**UNIFORM STANDARD DRAWINGS  
CLARK COUNTY AREA, NEVADA**

**YEAR 2017 REVISIONS**

AGENCY APPROVED	C	L	N
SPECIFICATION REFERENCE		UNIFORM STANDARD DRAWINGS CLARK COUNTY AREA			
302	AGGREGATE BASE	SUPPLEMENTAL DRAWING			
401	BITUMINOUS PAVEMENT	LOCAL RESIDENTIAL URBAN AREA STREET SECTIONS			
406	PRIME COAT				
407	FOG SEAL				
501	CONCRETE				
		DATE XX-XX-XX	DWG. NO.	206.S1

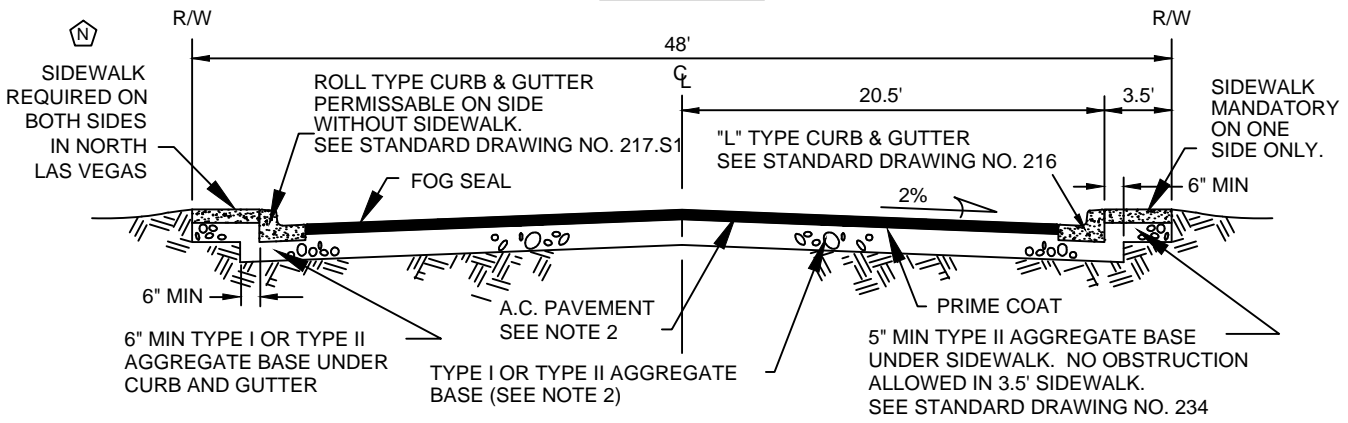
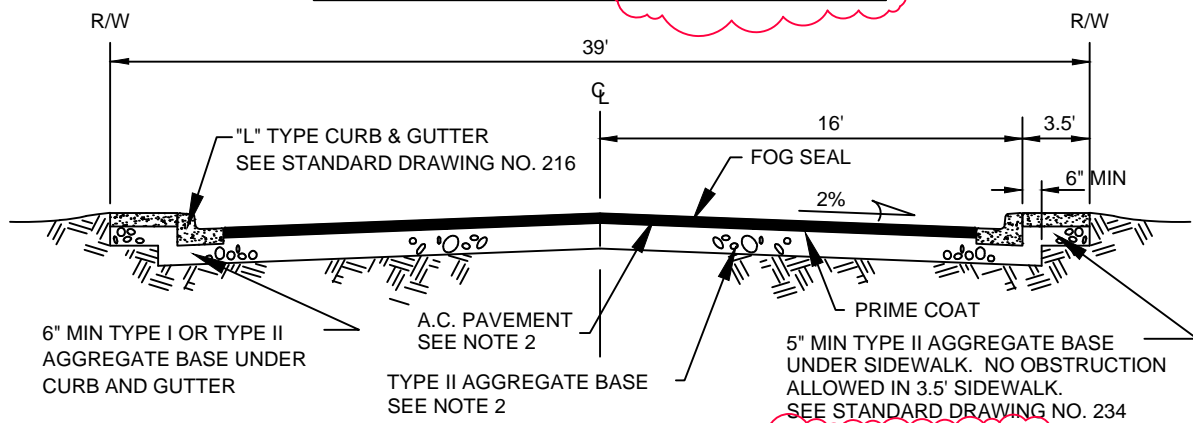
<b><u>DWG NO.</u></b>	<b><u>TITLE AND REVISIONS SUMMARY</u></b>	<b><u>EFFECTIVE DATE</u></b>
206.S1	"Local Residential Urban Area Street Sections" – Drawing revised to prohibit the use of Option B and One Way Residential Street Section in Clark County.	1/1/2017

**RESIDENTIAL TWO-WAY LOCAL CUL-DE-SAC (OPTION "B")  
(NOT ALLOWED IN CLV OR CLARK COUNTY)**

**RESIDENTIAL ONE-WAY (NOT ALLOWED IN CLV OR CLARK COUNTY)**

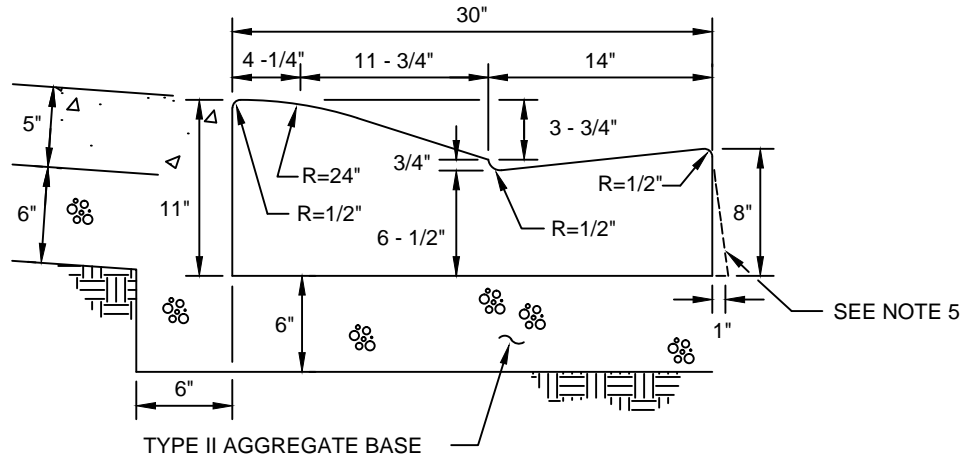
217.1	"30 Inch Modified Roll Curb and Gutter Residential Area" - New Drawing to help meet Americans with Disabilities Act Accessibility Guidelines.	1/1/2017

6. NO UTILITY BOXES AND COVERS ADJACENT TO R-TYPE 30 INCH MODIFIED ROLL CURB AND GUTTER RESIDENTIAL AREA SHALL BE ALLOWED AT DRIVEWAY LOCATIONS.

**B** 7. BOULDER CITY ENGINEER APPROVAL REQUIRED FOR USE OF 30 INCH MODIFIED CURB AND GUTTER RESIDENTIAL AREA .

AGENCY APPROVED		C	H	Ⓕ		Ⓖ
SPECIFICATION REFERENCE		UNIFORM STANDARD DRAWINGS CLARK COUNTY AREA						
320	AGGREGATE BASE	SUPPLEMENTAL DRAWING						
501	CONCRETE	30 INCH ROLL CURB RESIDENTIAL AREA						
502	CONCRETE STRUCTURES							
707	JOINT MATERIAL							
		DATE XX-XX-XX	DWG. NO.	217.2.S1

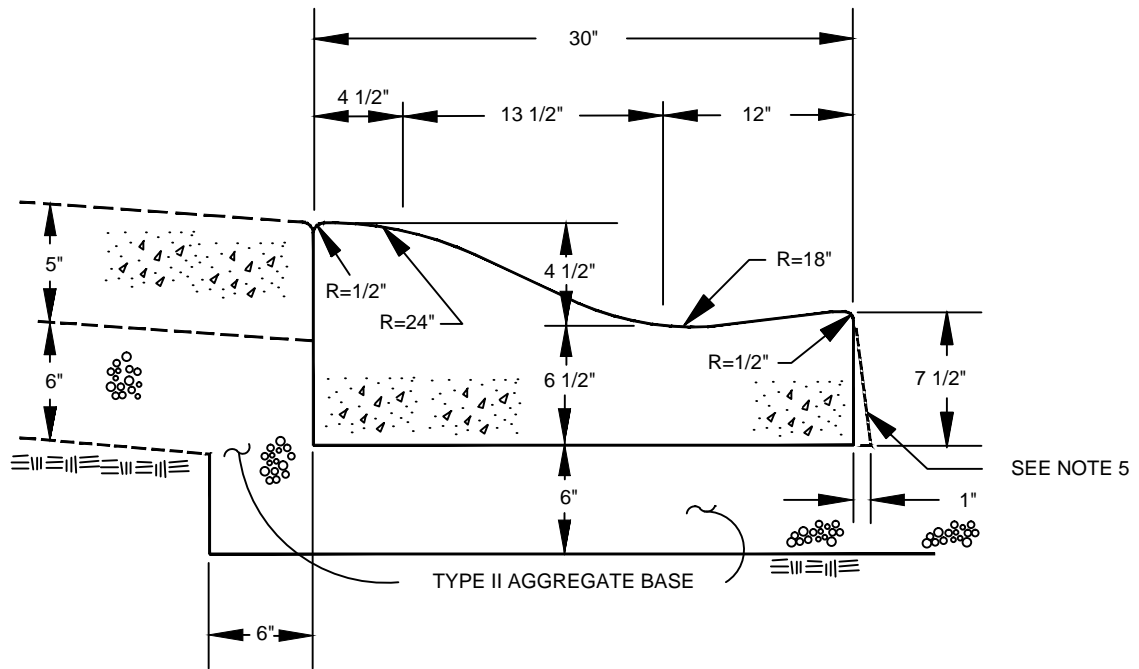
217.2.S1	"30 Inch Roll Curb Residential Area" - Drawing revised to help meet Americans with Disabilities Act Accessibility Guidelines.	1/1/2017
217.3.S1	"Residential Curb & Gutter R-Type" - Drawing revised to help meet Americans with Disabilities Act Accessibility Guidelines.	1/1/2017
224	"Commercial and Industrial Driveway (Option A)" - Drawing revised to help meet Americans with Disabilities Act Accessibility Guidelines.	1/1/2017
234	"Sidewalk" – Drawing revised to modify dimensions for weakened plane joint detail.	1/1/2017
319	"Lower Pole Details for Pipe and Mast Arm Poles" – Drawing revised to change dimensions of hand holes.	7/1/2017
806	"Signal Standard Type 1-A, 1-B" - Drawing revised to change dimensions of hand holes.	7/1/2017
808-1	"Type XX-30 Ft. Signal and Luminaire Pole (45 Ft. or less Mast Arms)" - Drawing revised to change dimensions of hand holes.	7/1/2017
808-2	"Type XX-30 Ft. Signal and Luminaire Pole Details" – Drawing revised to change dimensions of hand holes.	7/1/2017

- ~~8. ALL UTILITY BOXES AND COVERS ADJACENT TO ROLL CURB SHALL BE HS-20 RATED "TRAFFIC BEARING" TYPE~~
8. NO UTILITY BOXES AND COVERS ADJACENT TO R-TYPE 30 INCH MODIFIED ROLL CURB AND GUTTER RESIDENTIAL AREA SHALL BE ALLOWED AT DRIVEWAY LOCATIONS.

9. IF ROLL CURB IS APPROVED FOR OTHER AREAS LOCATIONS THAT ARE SUBJECTED TO REGULAR TRAFFIC, THEN ALL UTILITY BOXES AND COVERS ADJACENT TO R-TYPE CURB SHALL BE MEET HS-20-H20-44 FOR STEEL BOXES AND ANSI/SCTE 77-2007 (TIER-22) FOR FIBERGLASS POLYMER CONCRETE BOXES RATED "TRAFFIC BEARING" TYPE.

AGENCY APPROVED	B	C	H	L	M	N
UNIFORM STANDARD DRAWINGS CLARK COUNTY AREA						
TYPE XX-30 FT. SIGNAL & LUMINAIRE POLE (45 FT. OR LESS MAST ARMS)						
DATE 07-01-17	DWG. NO.	808	SHEET	1 OF 6

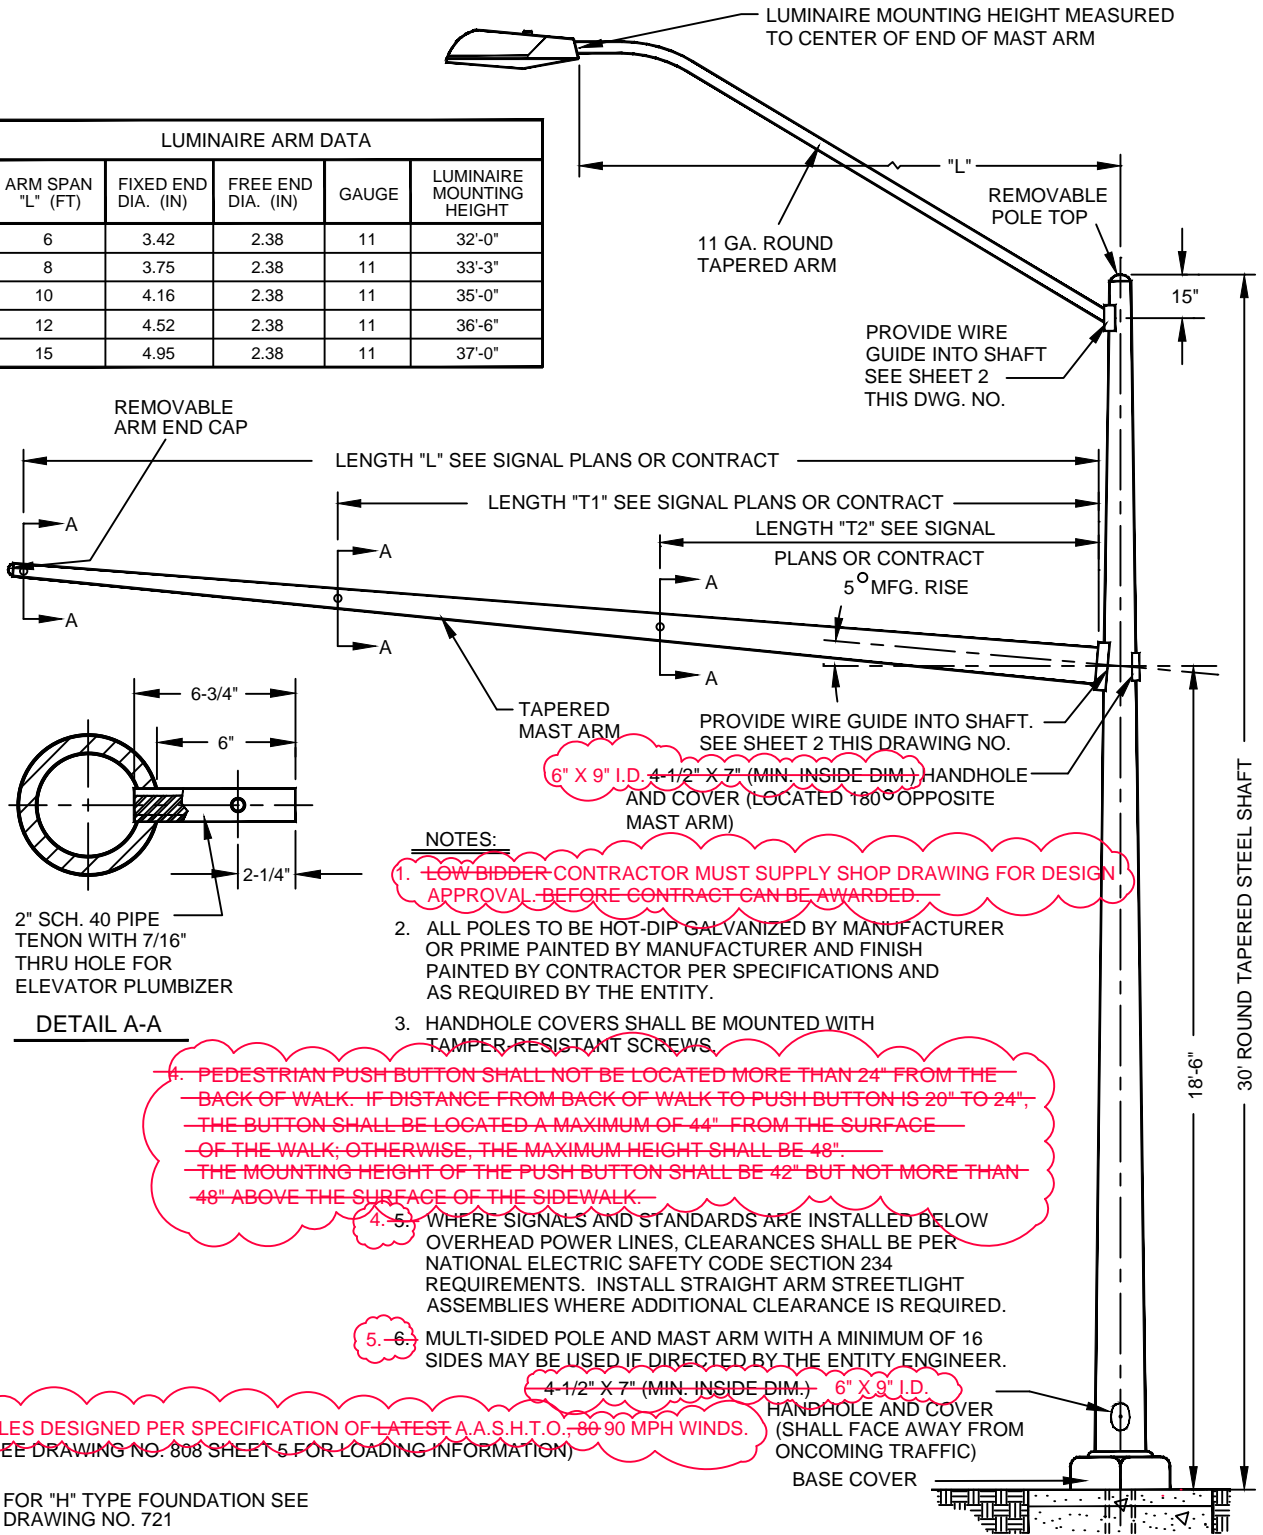
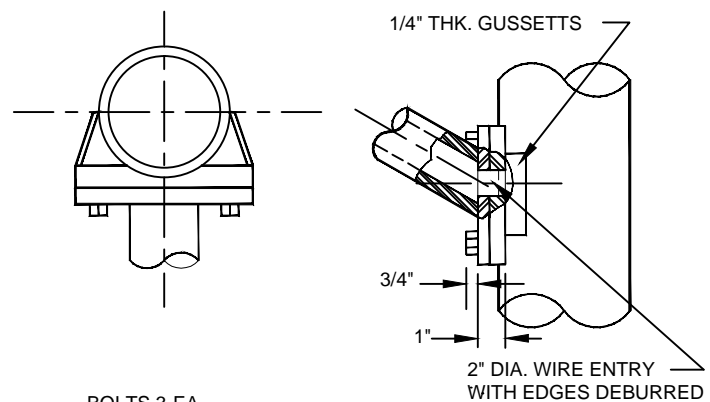
808-3	"Type XX-A-30 Ft. Signal and Luminaire Pole (45 Ft. or less Mast Arms)" – Drawing revised to Change dimensions of hand holes.	7/1/2017
808-4	"Type XX-A-30 Ft. (50 Ft. Thru 60 Ft. Mast Arms) Signal & Luminaire Pole Details" - Drawing revised to change dimensions of hand holes.	7/1/2017

~~4-1/2" X 7" (MIN. INSIDE DIM.) 6" X 9" I.D. HANDHOLE AND COVER (SHALL FACE AWAY FROM ONCOMING TRAFFIC)~~  
**POLES DESIGNED PER SPECIFICATION OF LATEST A.A.S.H.T.O., 80-90 MPH WINDS. (SEE DRAWING NO. 808 SHEET 5 FOR LOADING INFORMATION)**

1. ~~LOW BIDDER CONTRACTOR MUST SUPPLY SHOP DRAWING FOR DESIGN APPROVAL BEFORE CONTRACT CAN BE AWARDED.~~

4. ~~PEDESTRIAN PUSH BUTTON SHALL NOT BE LOCATED MORE THAN 24" FROM THE BACK OF WALK. IF DISTANCE FROM BACK OF WALK TO PUSH BUTTON IS 20" TO 24", THE BUTTON SHALL BE LOCATED A MAXIMUM OF 44" FROM THE SURFACE OF THE WALK; OTHERWISE, THE MAXIMUM HEIGHT SHALL BE 48". THE MOUNTING HEIGHT OF THE PUSH BUTTON SHALL BE 42" BUT NOT MORE THAN 48" ABOVE THE SURFACE OF THE SIDEWALK.~~

DATE 07-01-17	DWG. NO.	808	SHEET	2 OF 6
---------------	----------	-----	-------	--------

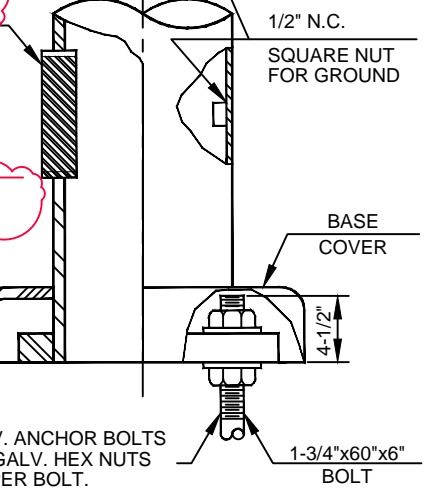
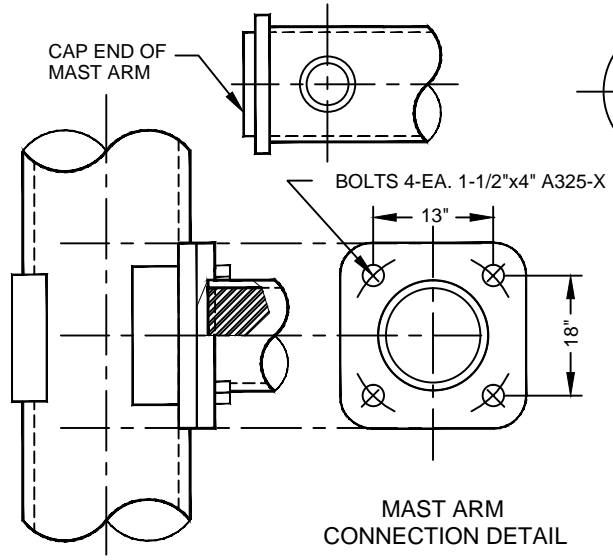
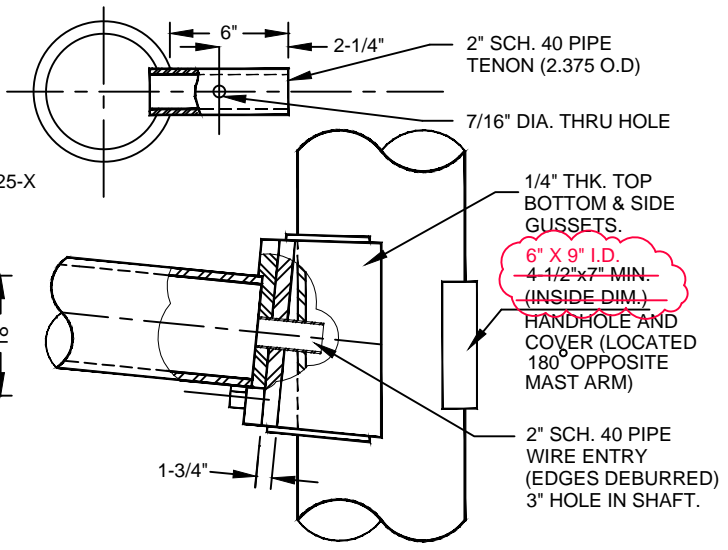
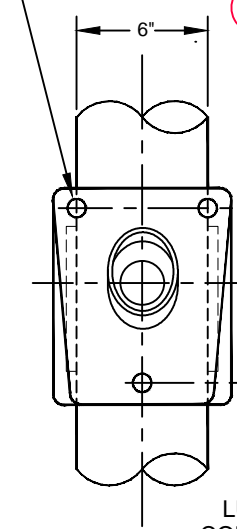
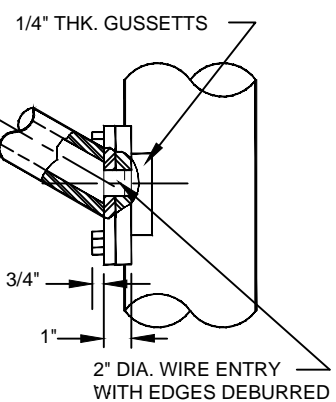
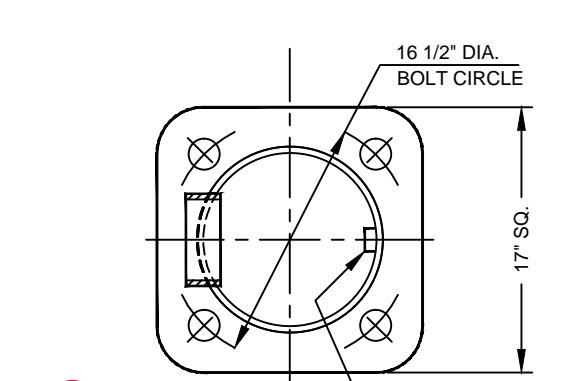
6" X 9" I.D.  
4-1/2" X 7" MIN.  
(INSIDE DIM.)

1. ~~LOW BIDDER CONTRACTOR MUST SUPPLY SHOP DRAWING FOR DESIGN APPROVAL. BEFORE CONTRACT CAN BE AWARDED.~~
2. ALL POLES TO BE HOT-DIP GALVANIZED BY MANUFACTURER OR PRIME PAINTED BY MANUFACTURER AND FINISH PAINTED BY CONTRACTOR PER SPECIFICATIONS AND AS REQUIRED BY THE ENTITY.

3. HANDHOLE COVERS SHALL BE MOUNTED WITH TAMPER-RESISTANT SCREWS.
4. ~~PEDESTRIAN PUSH BUTTON SHALL NOT BE LOCATED MORE THAN 24" FROM THE BACK OF WALK. IF DISTANCE FROM BACK OF WALK TO PUSH BUTTON IS 20" TO 24", THE MOUNTING HEIGHT OF THE PUSH BUTTON SHALL BE 42" BUT NOT MORE THAN 48" ABOVE THE SURFACE OF THE SIDEWALK.~~

LOADING INFORMATION

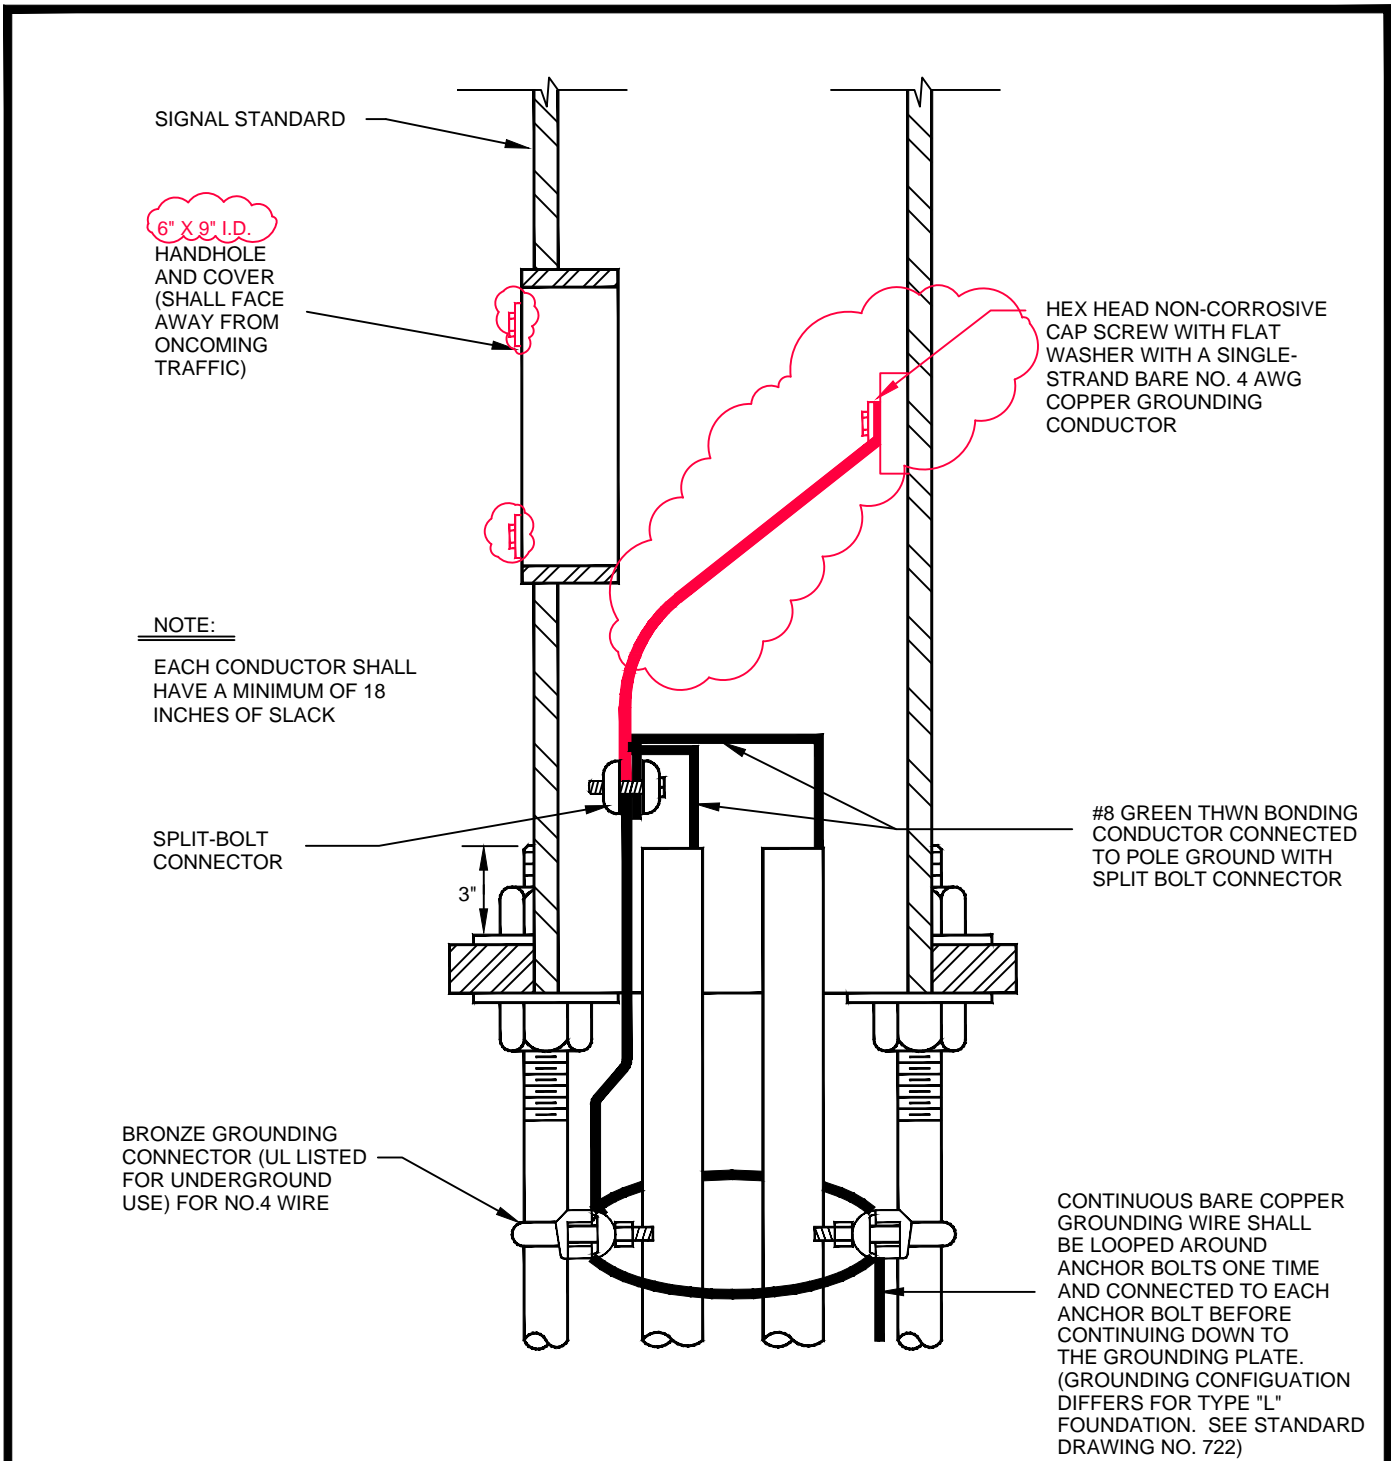
<b><u>DWG NO.</u></b>	<b><u>TITLE AND REVISIONS SUMMARY</u></b>	<b><u>EFFECTIVE DATE</u></b>
808-5	"Loading Information" – Drawing revised to change dimensions of hand holes.	7/1/2017
808-6	"Traffic Signal Pole Grounding" – Drawing revised to change dimensions of hand holes.	7/1/2017
810-1	"Type XX-B-30 Ft. Signal and Luminaire Pole (65 Ft. Thru 85 Ft. Mast Arms)" - Drawing revised to change dimensions of hand holes.	7/1/2017
810-2	"Type XX-B-30 Ft. (65 Ft. Thru 85 Ft. Mast Arms) Signal & Luminaire Pole Details" – Drawing revised to change dimensions of hand holes.	7/1/2017
810-3	"Loading Information" – Drawing revised to change dimensions of hand holes.	7/1/2017
812-1	"Type XX 20 Ft. Signal Pole (45 Ft. or less Mast Arms)" – Drawing revised to change dimensions of hand holes.	7/1/2017
812-2	"Type XX 20 Ft. (50 Ft. Thru 60 Ft. Mast Arms) Signal Pole" – Drawing revised to change dimensions of hand holes.	7/1/2017

6" X 9" I.D.  
HANDHOLE  
AND COVER  
(SHALL FACE  
AWAY FROM  
ONCOMING  
TRAFFIC)

AGENCY APPROVED	B	C	H	L	M	N
UNIFORM STANDARD DRAWINGS CLARK COUNTY AREA						
LOUVERED BACKPLATE FOR MAST ARM MOUNTED SIGNAL						
DATE 07-01-17	DWG. NO.	840

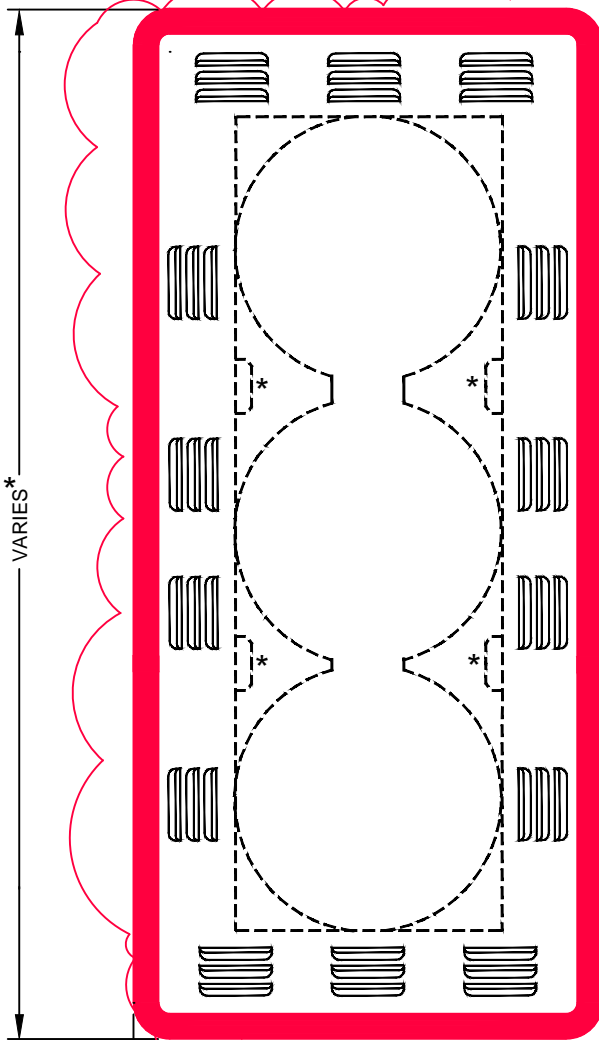
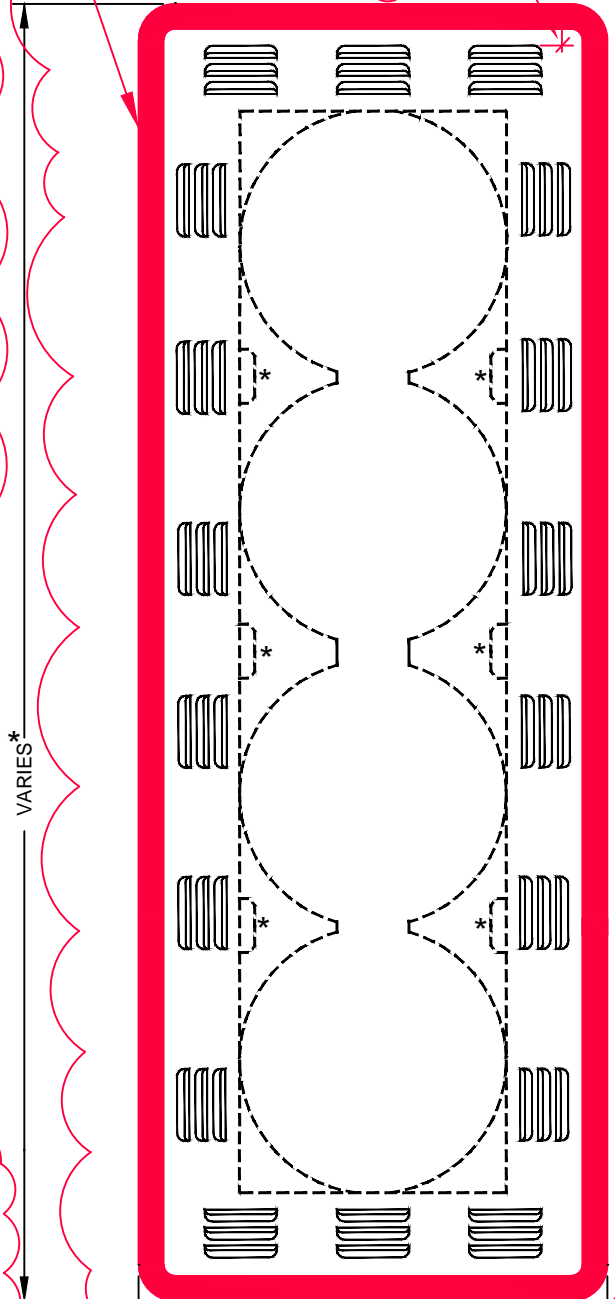
840	"Louvered Backplate for Mast Arm Mounted Signal" – Drawing revised to add the requirement for retroreflective traffic signal backplates.	7/1/2017
841	"Louvered Backplate for Pole Mounted Signal" – Drawing revised to add the requirement for retroreflective traffic signal backplates.	7/1/2017

2" YELLOW RETROREFLECTIVE BORDER LINE ADHESIVE SHEETING

1. ALL TRAFFIC SIGNAL BACKPLATES SHALL HAVE A 2-INCH RETROREFLECTIVE ADHESIVE SHEETING BORDER ON THE ENTIRE OUTER PERIMETER OF THE FRONT SIDE OF THE BACKPLATE.
2. RETROREFLECTIVE SHEETING SHALL BE FLUORESCENT YELLOW, ASTM D4956-13 TYPE XI OR BETTER.
3. THE RETROREFLECTIVE SHEETING BORDER SHALL HAVE A MINIMUM OF 0.5"
4. CLEARANCE FROM ALL LOUVERS. NO RETROREFLECTIVE SHEETING SHALL BE PLACED OVER ANY LOUVERED AREA.
5. RETROREFLECTIVE SHEETING BORDER SHALL BE INSTALLED BY THE MANUFACTURER, AND MODIFICATIONS SHALL NOT BE MADE BY THE CONTRACTOR.
6. THE BACK PLATE WITH RETROREFLECTIVE SHEETING BORDER SHALL BE FROM THE SAME MANUFACTURER AS THE SIGNAL HEAD ASSEMBLY. THE COMPLETE HEAD ASSEMBLY, INCLUDING THE BACKPLATE, SHALL BE CAPABLE OF WITHSTANDING WINDS OF 90 MPH WITHOUT DAMAGE OR SEPARATION OF ANY PARTS FROM THE SIGNAL HEAD ASSEMBLY.
